UNITED STATES PATENT AND TRADEMARK OFFICE

APPLICATION NO.	FILING DATE	FIRST NAMED INVENTOR	ATTORNEY DOCKET NO.	CONFIRMATION NO.
10/591,626	09/05/2006	Toshiaki Kawashima	S015-5846 (PCT)	3315

Office Action Summary	Application No. 10/591,626	Applicant(s) KAWASHIMA, TOSHIAKI	
	Examiner DAVID W. SCHEUERMANN	Art Unit 2834

DETAILED ACTION

FIG. 2

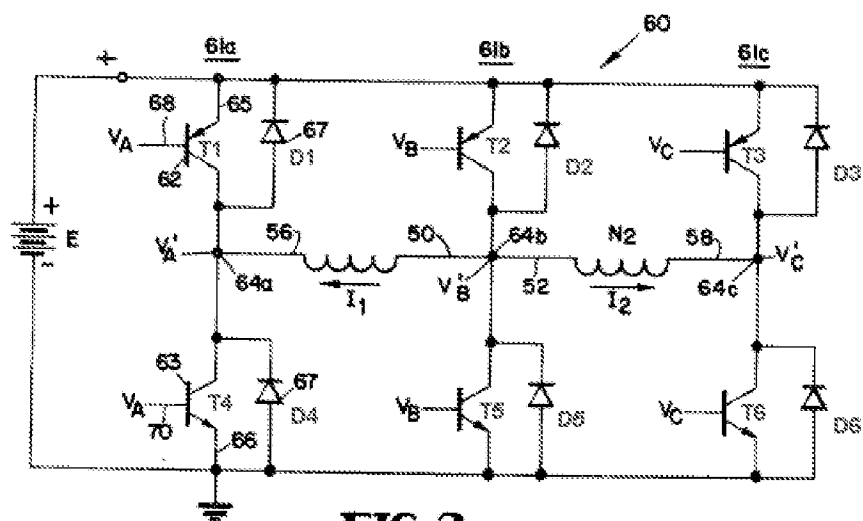
Re claim 1, a magnetic bearing device, (unless otherwise noted see marked up figure 2 below)

a rotor: (14, see figure 1)

a plurality of electromagnets (N1, N2) for controlling a radial position and/or an axial position of the rotor;

a power source (E, see figure 2) for supplying power to the electromagnets;

a common node (64b, see figure 2) commonly connected to each one end of the electromagnets;

switch means (T2, T5) for switching a voltage of the common node (64b, see figure 2);

and excitation control means (T4, T6) for controlling excitation of each of the electromagnets by a supply current that is supplied from the other end (64a, 64c) of one of the electromagnets to a negative electrode of the power source and that flows through the electromagnets in one direction (at a time), or by a regenerated current that is regenerated from the other end (64a, 64c) of one of

the electromagnets to a positive electrode (via D1, D3) of the power source and that flows through the electromagnets in one direction (at a time);

a first switch element for connecting and disconnecting between the positive electrode (T2) and the common node (64b, see figure 2); and

a first rectifier element (D5) for causing a current to flow from the negative electrode to the common node (64b, see figure 2); and

a second switch element (T4, T6) for connecting and disconnecting between the other end (64a, 64c) of one of the electromagnets and the negative electrode; and

a second rectifier element (D3, D1) for causing a current to flow from the other end (64a, 64c) of one of the electromagnets to the positive electrode.

Re claim 27, a magnetic bearing device, (unless otherwise noted see marked up figure 2 below)

a power source (E, see figure 2) for supplying power to the electromagnets;

a common node (64b, see figure 2) commonly connected to each one end of the electromagnets;

a switching circuit that switches a voltage of the common node (64b, see figure 2), the switching circuit including a first switch element (T2) for connecting and disconnecting between one end of the power source (E "+", see figure 2) and the common node (64b, see figure 264a, 64c), and a first rectifier element (D5) connected between the other end of the power source (E "-", see figure 2) and the common node (64b, see figure 2); and

an excitation control circuit (T1-T6) that controls excitation of each of the electromagnets by a supply current that flows through the electromagnets in one direction (at a time) or a regenerated current that flows through the electromagnets in one direction (at a time) , the excitation control circuit including a second switch element (T4, T6) that connects and disconnects between the other end (64a, 64c) of one of the electromagnets and the other end of the power source (E "-", see figure 2) , and a second rectifier element (D1, D3) connected between the other end (64a, 64c) of one of the electromagnets and the one end of the power source (E "+", see figure 2) .

Re claims 13 and 31, note that D5 is in parallel with T5 as shown in the figure, supra.

Re claims 26 and 29, note that second switch element (T4, T6) and second rectifier element (D3, D1) are formed of a single component as shown in figure 2, supra.

FIG. 2.1

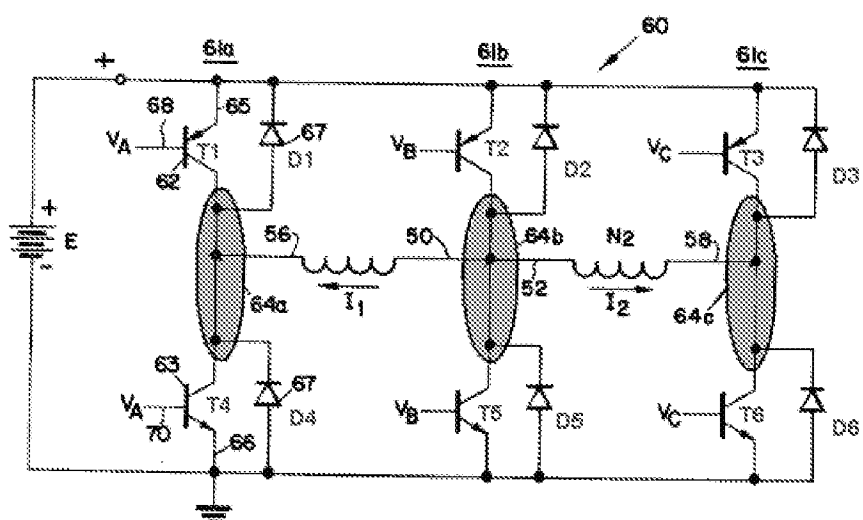
The following rendition shows the common note and the “other end” as shaded ellipses for clarity.

shows the common note and other end as shaded ellipses
